City of Apache Junction
Development Services Department

**PLANNING AND ZONING COMMISSION
PUBLIC HEARING STAFF REPORT**

CASE NUMBER: P-26-4-PZ "Banyan Apartments"

REQUEST: Proposed planned development rezoning of
approximately 6.7 net acres currently
zoned High Density Multiple-Family
Residential ("RM-2") to High Density
Multiple-Family Residential by Planned
Development ("RM-2/PD") with a new planned
development overlay to authorize an
amendment to the development plans
approved in Ordinance No. 1526 for the
development of a 146 unit, 2-story
apartment complex.

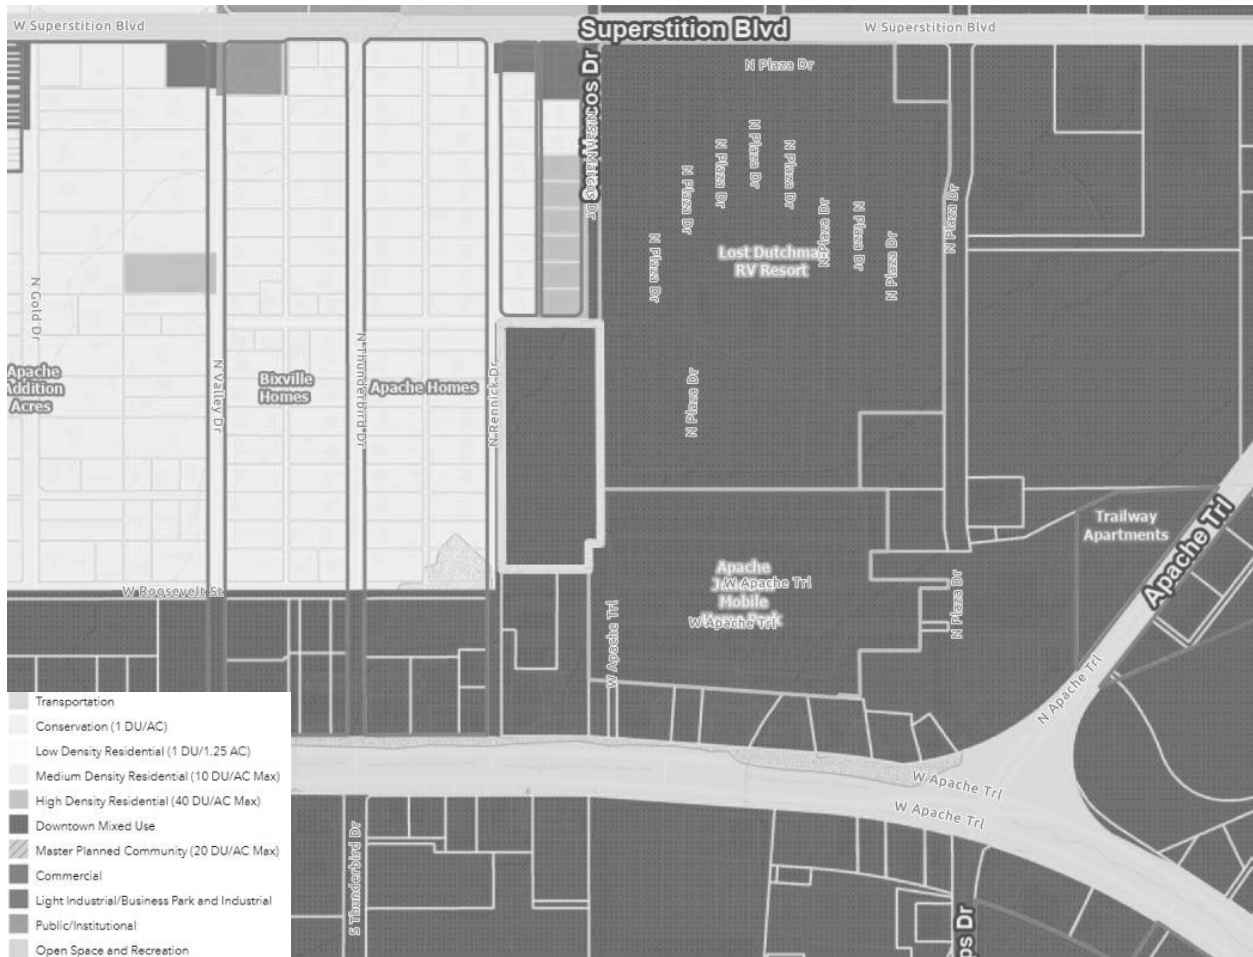
The total parking requirement is 314 parking spaces, however only 248 are proposed within the site, with an additional 6 spaces being located outside the front gate for access to the leasing office/clubhouse.

The applicant provides their rationale for this deviation in their project narrative (Exhibit #1) and in the included Planned Development Findings of Fact, however planning staff is not supportive of the proposed deviation, finding concern with the applicability of the rationale that the households utilizing the LIHTC program will consistently have less vehicles per household. A higher dependence on public transportation is a notable cited reason that we do not find applicable, with the city having no public transit options to be used instead of personal vehicles.
